UNITED STATES PATENT AND TRADEMARK OFFICE

APPLICATION NO.	FILING DATE	FIRST NAMED INVENTOR	ATTORNEY DOCKET NO.	CONFIRMATION NO.
10/760,110	01/16/2004	Marc Vincent Marini	0212.67006	7346
24978	7590	10/03/2006	EXAMINER	
GREER, BURNS & CRAIN 300 S WACKER DR 25TH FLOOR CHICAGO, IL 60606			TALBOT, MICHAEL	
			ART UNIT	PAPER NUMBER
			3722

Office Action Summary

DETAILED ACTION

FIG. 18

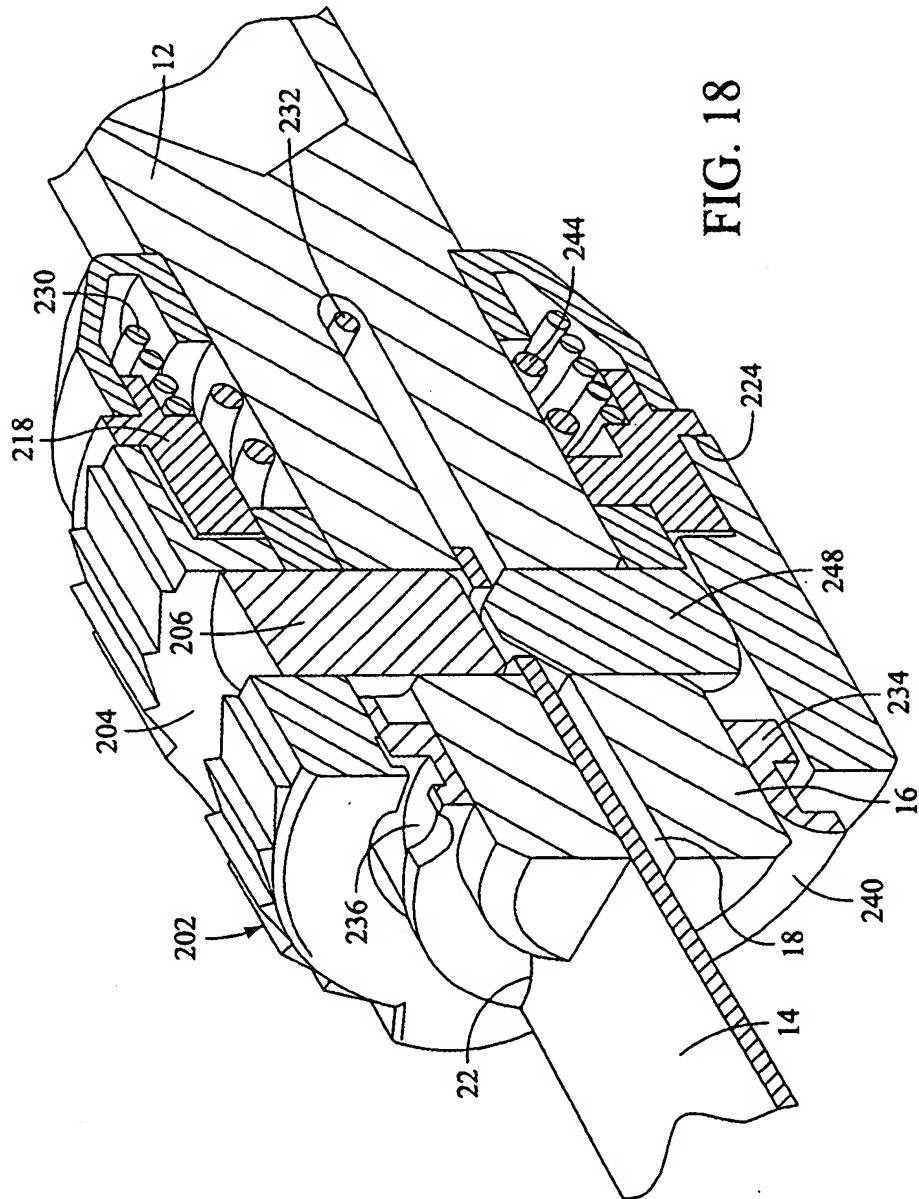
1. The drawings are objected to as failing to comply with 37 CFR 1.84(p)(5) because they do not include the following reference sign(s) mentioned in the amended description replacing paragraph beginning at page 12, line 1: "axial rib 211" described in Applicant's Amendment filed 18 August 2006 on page 4. Corrected drawing sheets in compliance with 37 CFR 1.121(d) are required in reply to the Office action to avoid abandonment of the application. Any amended replacement drawing sheet should include all of the figures appearing on the immediate prior version of the sheet, even if only one figure is being amended. Each drawing sheet submitted after the filing date of an application must be labeled in the top margin as either "Replacement Sheet" or "New Sheet" pursuant to 37 CFR 1.121(d). If the changes are not accepted by the examiner, the applicant will be notified and informed of any required corrective action in the next Office action. The objection to the drawings will not be held in abeyance.

In addition to Replacement Sheets containing the corrected drawing figure(s), applicant is required to submit a marked-up copy of each Replacement Sheet including annotations indicating the changes made to the previous version. The marked-up copy must be clearly labeled as "Annotated Sheets" and must be presented in the amendment or remarks section that explains the change(s) to the drawings. See 37 CFR 1.121(d)(1). Failure to timely submit the proposed drawing and marked-up copy will result in the abandonment of the application.
